WOODBURY COUNTY BOARD OF SUPERVISORS AGENDA ITEM(S) REQUEST FORM

Approval of Final Plat for the Walnut View Minor Subdivision

WALNUT VIEW

MINOR SUBDIVISION PROPOSAL

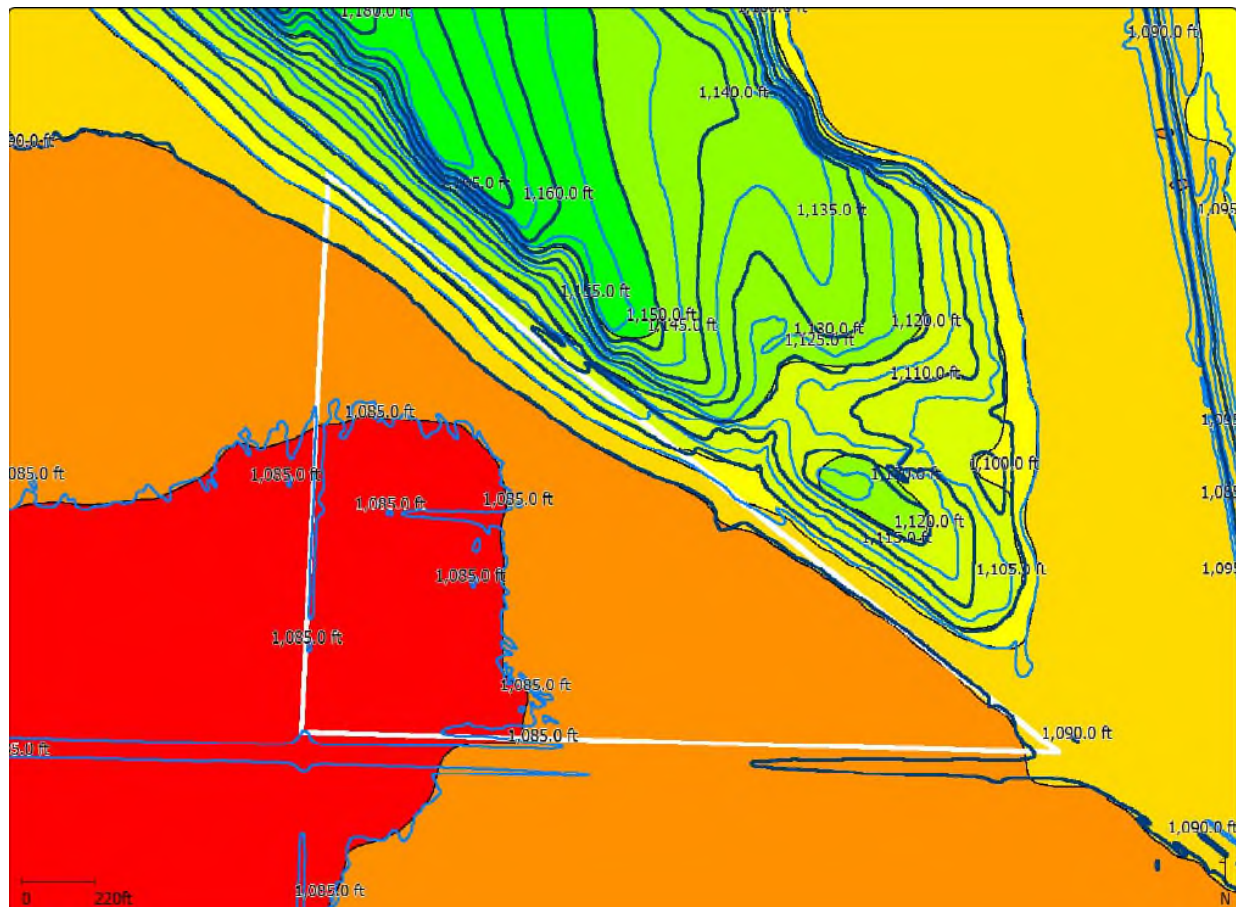
Dan, attached is a map from the Iowa Flood Center. I suppose the county has seen this information as it reevaluates the flooding potential of the Walnut View subdivision but I wanted to be sure you have it as part of my argument that this tract of land is unfit for residential development.

Here's a map of elevations. Noteworthy is the fact that much of the ground is lower than the elevation in the extreme SE corner of the tract and that corner is the only area designated in the floodplain of the FEMA map.

FLOODPLAIN ANALYSIS & RECOMMENDATION

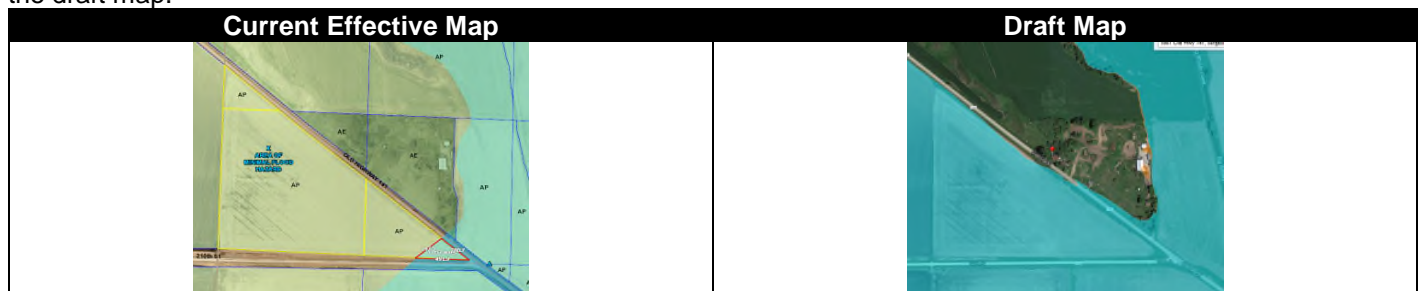
During the past year, the Iowa Department of Natural Resources (IDNR) and the Federal Emergency Management Agency (FEMA) have been developing a new floodplain map based on 2 ft. LiDAR intervals. The new maps are presently in the draft phase and have not been formally presented to the county for adoption. The current effective map is the map that is enforced by the county floodplain ordinance and the use of the draft map proposal can only be considered for informational purposes.

The current floodplain map includes a majority of this property as not being located with the special floodplain hazard area (SFHA). Presently, there is about 1.057 acres of floodplain located on the proposed outlot of the minor subdivision which is not meant for development. However, the draft map proposal almost entirely places the area proposed for the subdivision into the future floodplain.

On June 5, CED staff attended a flood risk review meeting with representatives from the IDNR and FEMA and this situation was brought to their attention. The staff inquired about the discrepancy between the two maps (see below). Vikram Shrivastava, a FEMA contractor, stated that "we are investigating the area near Old Hwy 141 and the widening floodplain. I will get back to you in the next 2 weeks on our findings." This investigation could result in a modification to the draft map.

The staff recommends that the Zoning Commission recommend and the Board of Supervisors approve this minor subdivision proposal based on the condition that the developer be required as per Bill Cappuccio's comments to determine the base flood elevation (BFE) through the IDNR's office and be subject to the Woodbury County floodplain development ordinance including new structures built one (1) foot above the BFE .

FINAL PLAT OF
Walnut View,
A MINOR SUBDIVISION TO WOODBURY COUNTY, IOWA

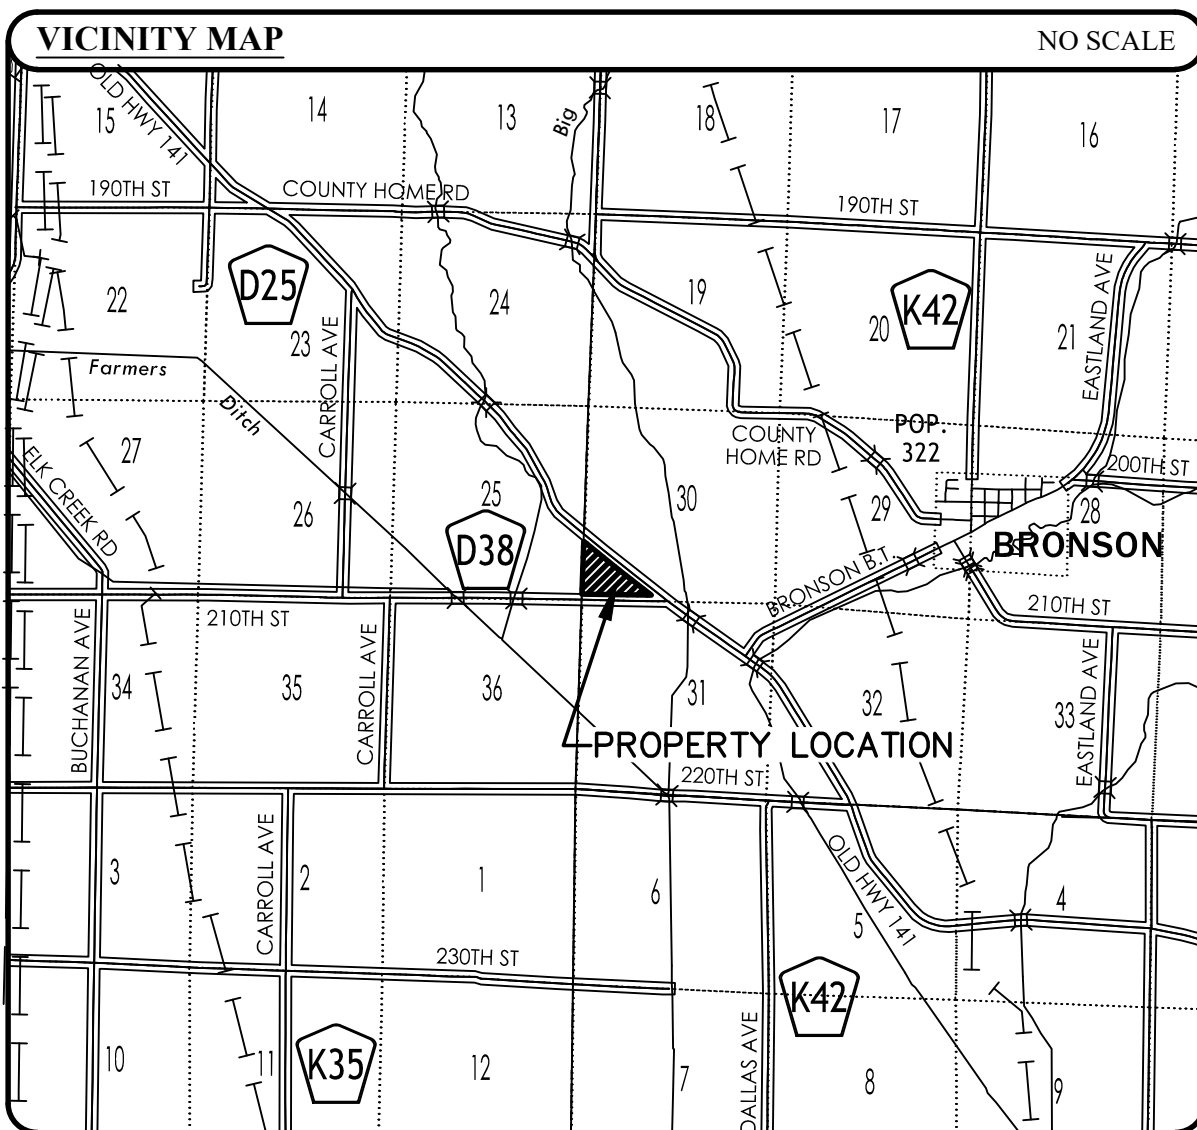
- We checked the closure on the plat and found it in compliance with the requirements for the full subdivision of 1 in 10,000 and 1 in 5,000 for each lot as required by Section 355.8 of the Code of Iowa.

- I reviewed the subdivision for access. Normally for a subdivision with this many lots, I would prefer to see the lots serviced by an internal street or cul-de-sac to reduce the possible points of collision conflict on a major roadway. This option has not been offered by the developer. Stripping lots along a roadway, as is proposed with the Walnut View subdivision, increases the risk of collision for vehicles using Old Highway 141 and D38. Old Highway 141 is a heavily used road with an average daily traffic count of 1370 vehicles per day (vpd) for this road segment. D38/210th Street has a traffic count of 980 vpd. Options for a cul-de-sac or a frontage road serving the subdivision could have been offered, and would offer safer alternatives for access to the lots. I realize that this is costlier for the developer, but it does result in fewer potential collision conflicts for road users and safer conditions for adjacent residents.

A series of driveways on strip subdivisions frequently leads to a request for a speed limit on the adjacent road. A more restrictive speed limit on Old Highway 141 is not in concert with the road classification and use, which is major collector route/farm to market route/commuter route. Spot speed limits in locations like this are difficult to enforce and result in poor compliance and complaints to our department. Compare this spot to the Holly Springs speed zone which is frequently violated and subject of complaints of noncompliance with the 35-mph speed limit. If given my choice on the development of subdivisions with more than 3 or 4 lots, I would prefer to see the lots served by an internal roadway such as was done with the Dunn Estates, Niles Second

I am resistant to the request for individual driveways for each lot and would prefer to see the adjacent lots utilize shared driveways to reduce the number of new points of conflict along the road. Knowing the developer's intentions, I checked each lot frontage for establishment of a single driveway. Some lots will require shared driveways due to sight distance limitations. I will lay out two options for serving the subdivision with driveways.

- This area platted for this subdivision was subject to severe flooding during the March 2019 event. D38 between the Old 141 intersection and the eastern county bridge on D38 was underwater for over a week. The field from which the subdivision is being split was flooded during much of this period. Due to the winter conditions and snow filled ditches, the normal water courses were not carrying water or passing it to the improved drainage ditches west of the proposed subdivision and the water was forced to find its outlet by running through the field and overtopping the road. The Old 141/D38 intersection has been underwater due to flash flooding on Whiskey Creek four times since 2009. This has inundated the area shown as Outlot A and part of Lot 11 during those flood events. To protect the potential homes in the area, a base flood elevation for the lots within the subdivision should be established to assure that any eventual construction is set at an elevation above any likely flooding.

Option 1: Individual driveways

Option 2 – preferred:

Lot 1 – solo driveway

Lot 2 and 3 – shared driveway at corner due to limited sight distance

Lot 4 - solo driveway

Lot 5 and 6 – shared driveway at corner due to limited sight distance

Lot 7 and 8 – shared driveway

Lot 9 and 10 – shared driveway

Lot 11 and Outlot A – shared driveway

Lot 12 and 14 – shared driveway
